CITY OF NORTH OAKS

Regular Planning Commission Meeting
Thursday, April 25, 2024
7:00 PM, Community Meeting Room, 100 Village Center Drive
MEETING AGENDA

7a. Public Hearing - Consider Conditional Use Permit for building height in excess of 35 feet for property located at 8 Sherwood Trail. Consider driveway setback variance.
[2024-04-25 PC Packet_8 Sherwood Trail.pdf](#)

PLANNING REPORT

Figure 2- preliminary plans

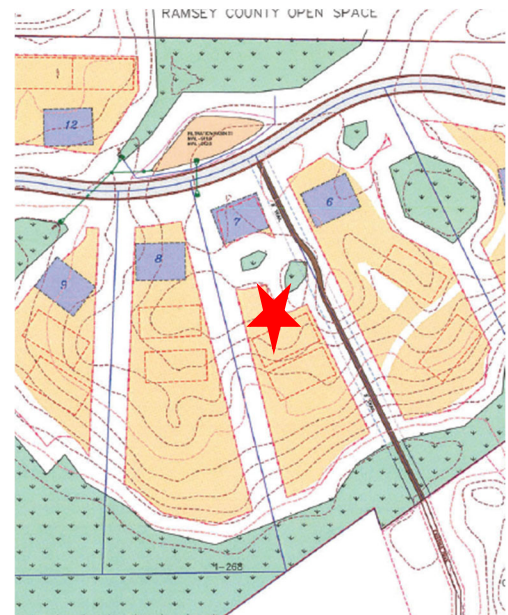
1. *The front elevation of the building does not exceed 35 feet in height at any point;*

The proposed front elevation does not exceed 35 feet at any point.

- 2. The building height at any other elevation does not exceed 45 feet;*

Based on review of the plans, topography of the site and Ramsey County GIS, the proposed home and walkout level appear conducive to the site's natural layout in this location. Prior to construction, the City will review all erosion control measures to ensure that the construction project does not adversely affect the surrounding environment. The City Engineer will make periodic site visits during construction to ensure all erosion control measures are fully complied with.

Figure 3-Option 1

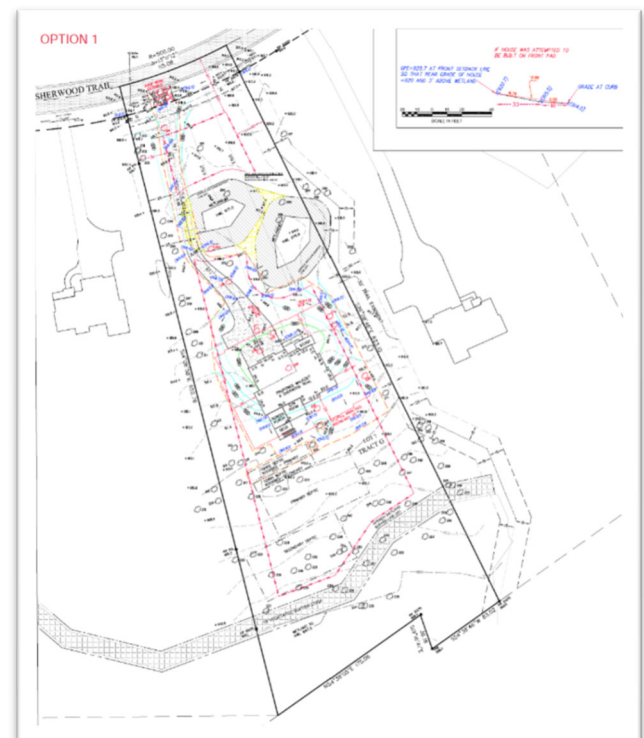
Option 1 requires less of a variance when the setback variation from the required side yard setback and wetland setback is evaluated but it impacts more sq. ft. of buffer than Option 2 according to the applicant's plan.

(1)(a) Their strict enforcement would cause practical difficulties because of circumstances unique to the individual land under consideration, and the variances shall be granted only when it is demonstrated that the actions will be in keeping with the spirit and intent of this chapter.

The applicant argues that they bought the lot, entered into a purchase agreement with a buyer and the house they want to build does not fit on the front building pad. Hanson Builders argues that this creates a practical difficulty

because they cannot build a home like others they are building in the neighborhood without the driveway variance and placing this house up by the street will look out of character with the other homes in the neighborhood.

The Commission could find there is no practical difficulty and the landowner simply needs to develop a home plan that fits the lot without the need for a variance. The final plans/plat for Red Forest Way South Phase 1 showed the house pad on the front of the lot. The approvals for the subdivision were based on the approved plans and due diligence as part of the land purchase should have identified this home site. The City Code prohibits the creation of parcels that are unbuildable and the developer showed a driveway and home site that they deemed buildable when the lot was created.

Hanson Builders has provided a detailed narrative outlining what they believe are the practical difficulties that necessitate the variance. They argue that the small building pad in the front of the lot is out of character with other homes in the neighborhood and the home needs to be behind the wetlands to build the home the buyer wants. They also make the argument that the driveway would be too steep if they built on the house pad in the front of the lot. The City Engineer has reviewed the plans and concurs that the originally approved home site would require a driveway grade in excess of 10% in order to meet the code requirements for the low floor elevation of the home and that is in excess of standard practice.

The Planning Commission must evaluate whether or not the original building pad proposed by The North Oaks Company and approved by the City is a reasonable location or whether the location is not feasible and creates a practical difficulty. The Commission could agree with Hanson Builders that the house they designed does not fit on this lot, but find that is not a practical difficulty, because a different home could be designed to work with the site conditions and not require a variance. The Commission could find that while not ideal, a driveway with a grade in excess of 10% could be constructed and such driveways do exist in the region.

The applicant argues that the variance is the minimum action needed to alleviate the practical difficulties on site because the house they want to build won't fit on the approved building pad site and that a house that could fit would be out of character with the neighborhood. The variance is the minimum action necessary to allow the builder to build the selected home plan on this lot.

Alternatively, the Commission could find that the variance is not the minimum action necessary as the driveway width could be reduced from 12 feet to 10 feet to reduce the variance. The Commission could find that there is no practical difficulty because the building pad site as approved can be developed but simply requires the builder to develop a smaller house plan that works with the existing site.

The Commission asked for two options from the applicant. Staff finds that Option 1 (with the driveway reduced to 10 feet at the wetland) results in the minimum amount of variance to allow a home to be constructed on the rear portion of the lot. If the Commission finds that the variance standards have been met for Option 1, staff recommends the following conditions of approval:

1. The driveway must be reduced from 12 feet to 10 feet wide at the narrowest point to minimize the wetland impact. This will increase the wetland buffer from 11 to 13 feet wide in that location.
2. Wetland buffer averaging must be used as shown on the plans.
3. Wetland buffer signs must be installed at the edge of the wetland buffer to protect the buffer. Buffer signs should be planted where needed to indicate the contour of the buffer, with a maximum spacing of 200 feet of wetland edge. The signs and sign plan must be submitted to City staff for review and approval.
4. Wetland buffer plantings must be installed to ensure quality vegetation to maximize the buffer benefits. A wetland buffer planting plan must be submitted to City staff for review and approval.

OPTION 1

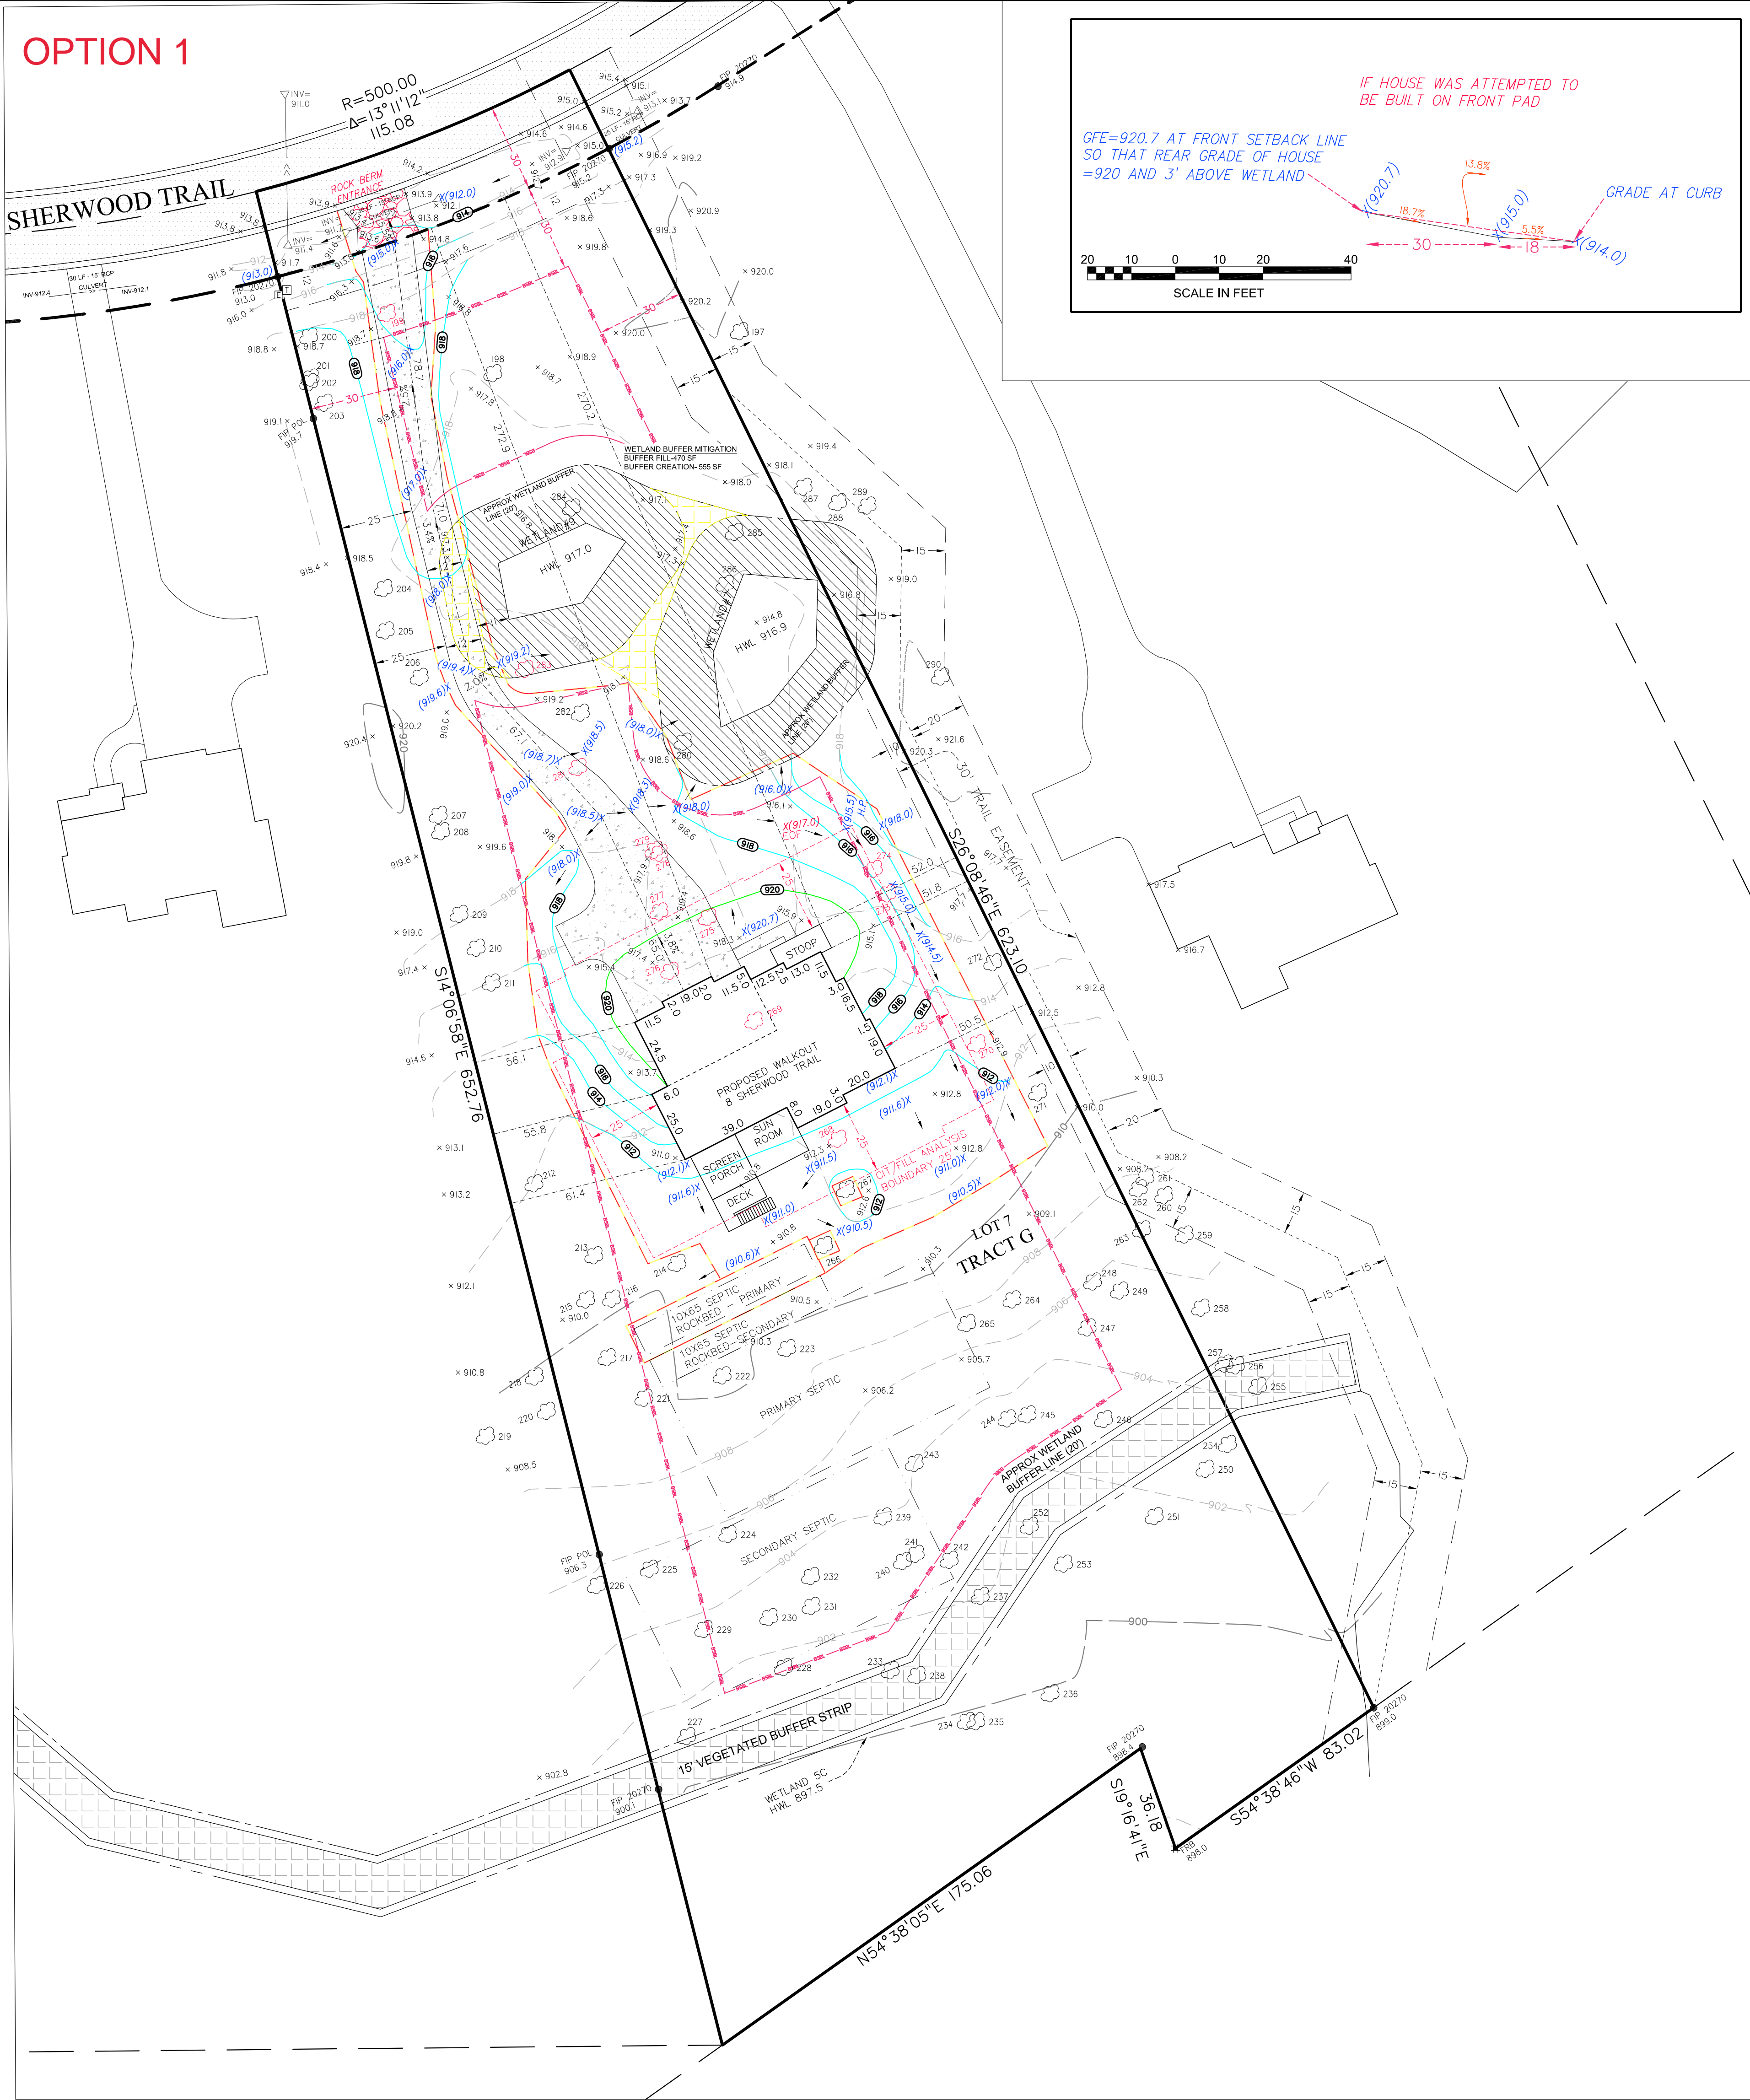
- Per buffer rules adopted by the City Option #1 will work. Buffer width may vary based on demonstrated site constraints, provided that a width of at least 50 percent of the Applied Buffer Width is maintained at all points; there is no reduction in total buffer area; and the buffer provides wetland and habitat protection at least equivalent to a buffer of uniform Applied Buffer Width. For this option it is recommended that a minimum of 12’ buffer be utilized from driveway edge to wetland line to follow adopted buffer rules. Plan sheet Option #1 TRACT G, L7, EAST PRESERVE, 8 SHERWOOD TRAIL - COS 032924[100]

OPTION 2

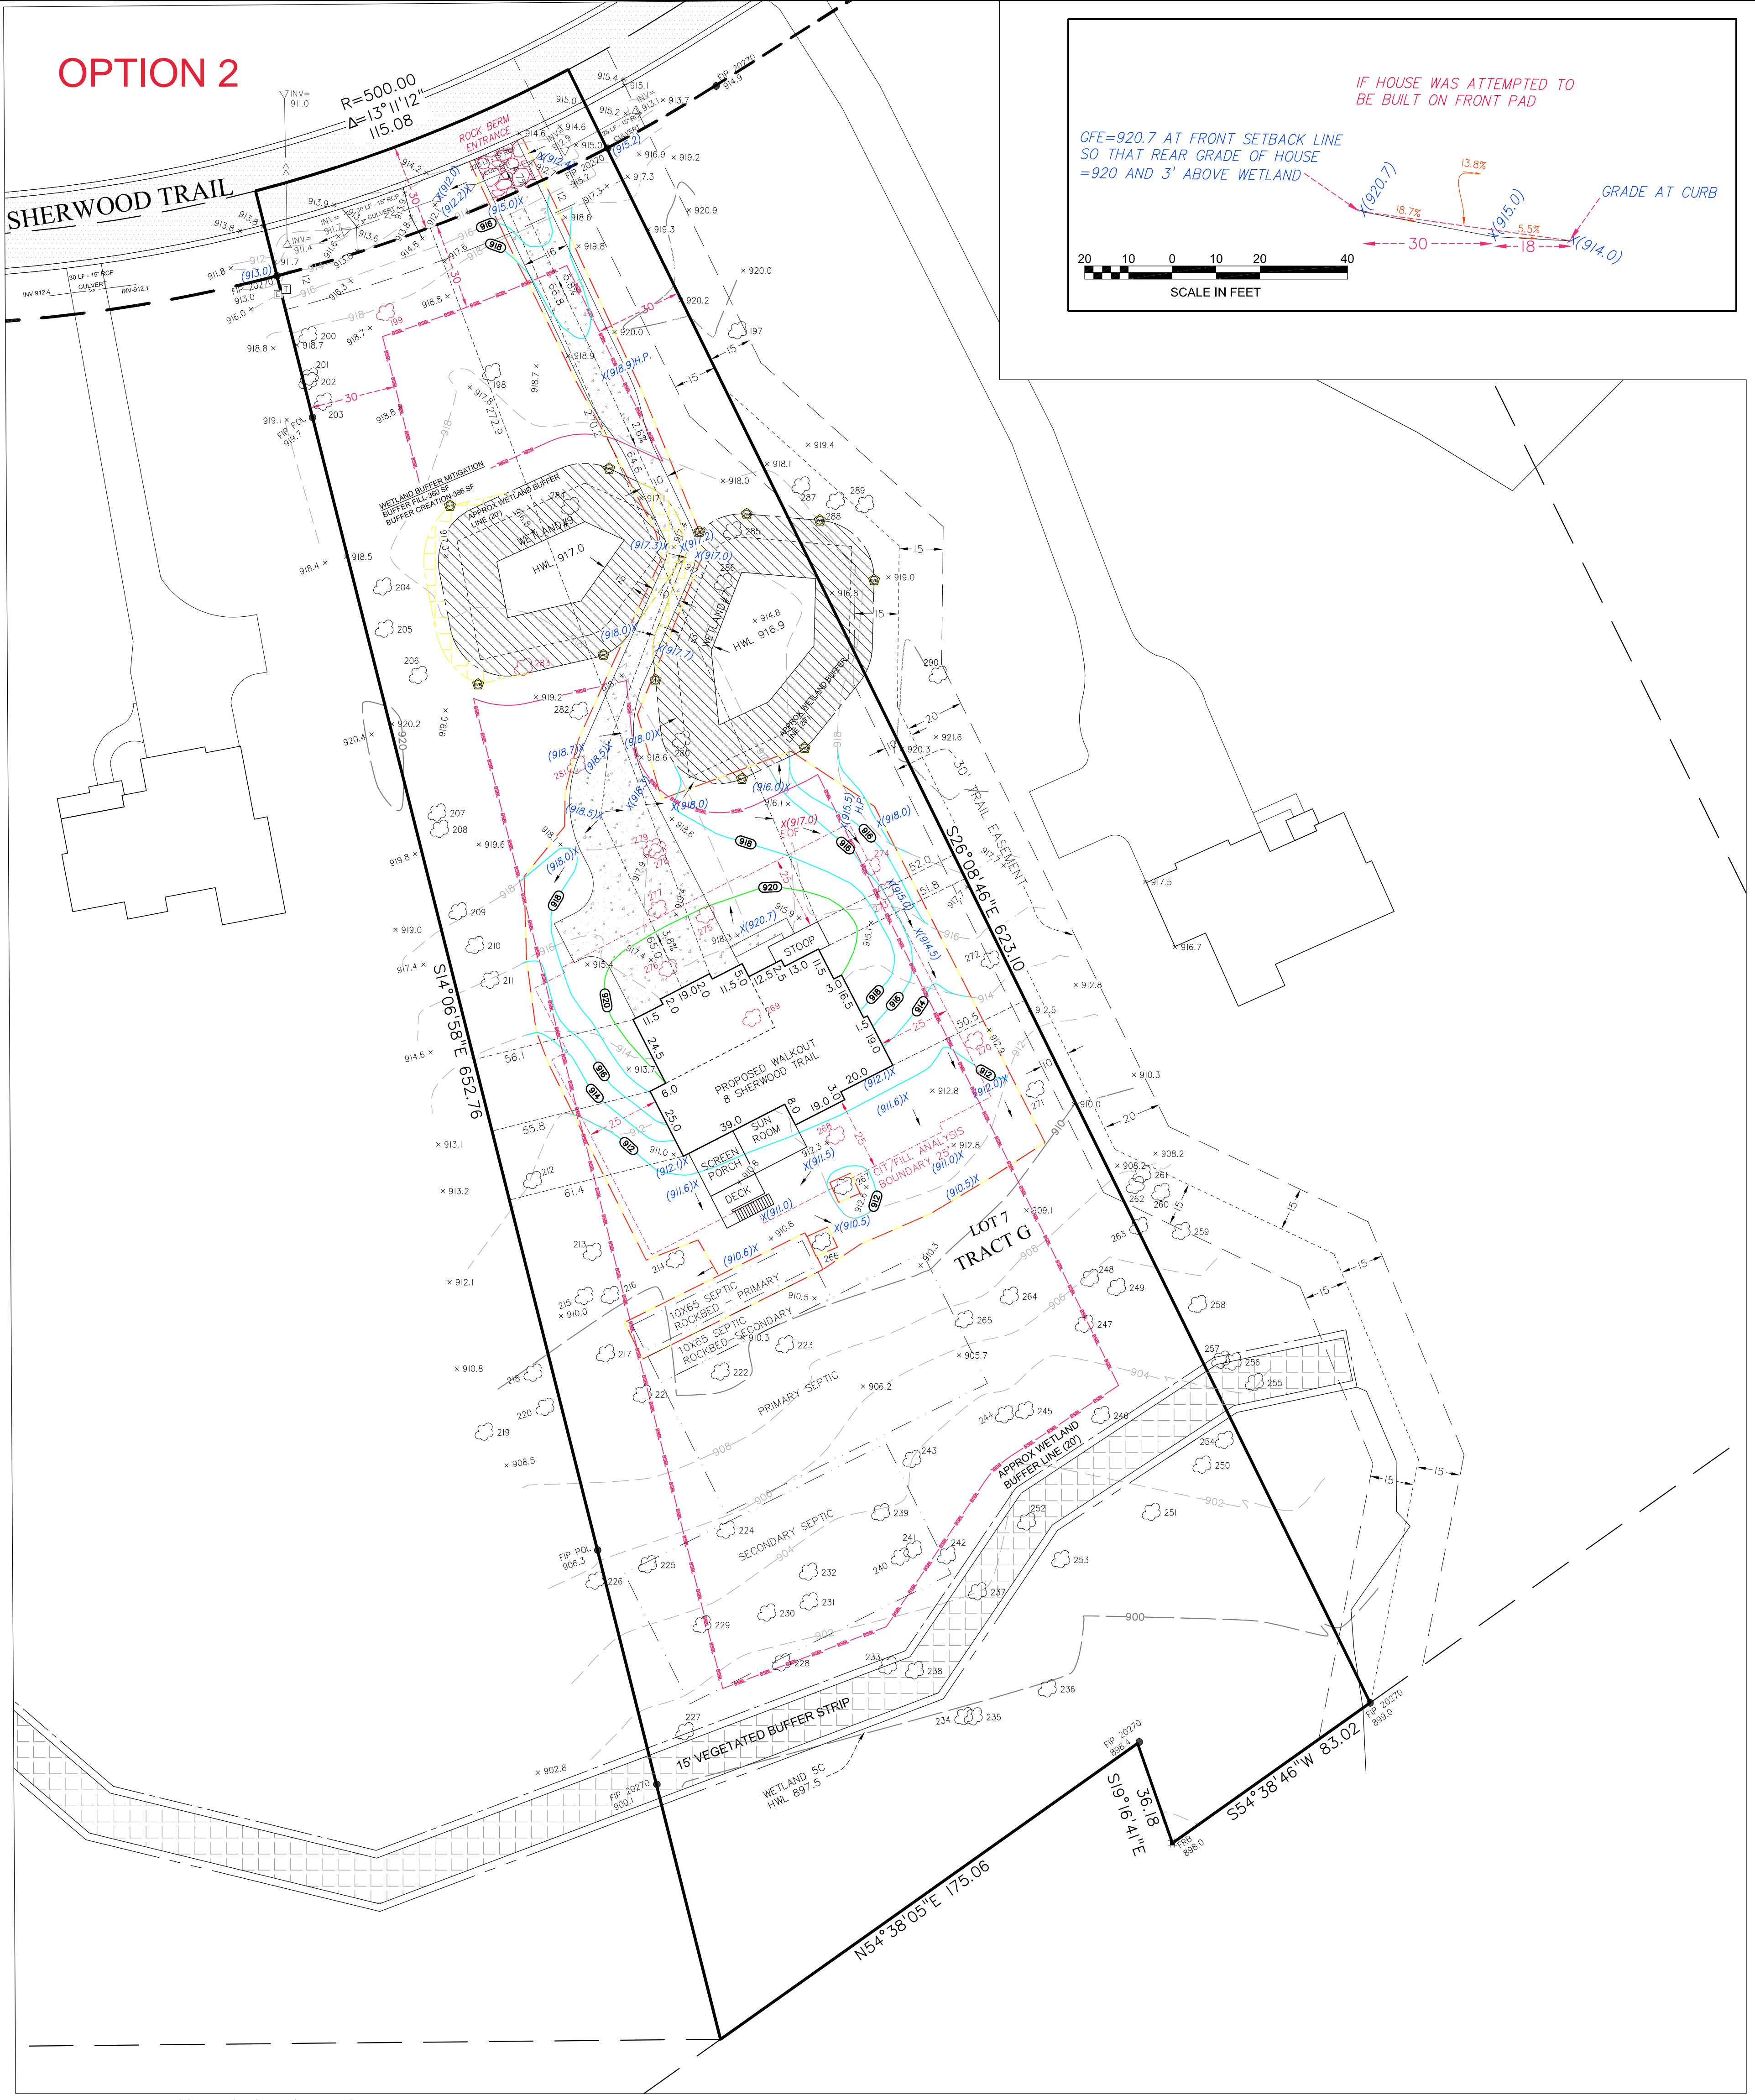
- Per buffer rules adopted by the City Option #2 will work. Buffer width may vary based on demonstrated site constraints, provided that a width of at least 50 percent of the Applied Buffer Width is maintained at all points; there is no reduction in total buffer area; and the buffer provides wetland and habitat protection at least equivalent to a buffer of uniform Applied Buffer Width. This option follows adopted rules and slightly increases overall buffer around both wetlands. Plan sheet Option #2 TRACT G, L7, EAST PRESERVE, 8 SHERWOOD TRAIL - COS 040524
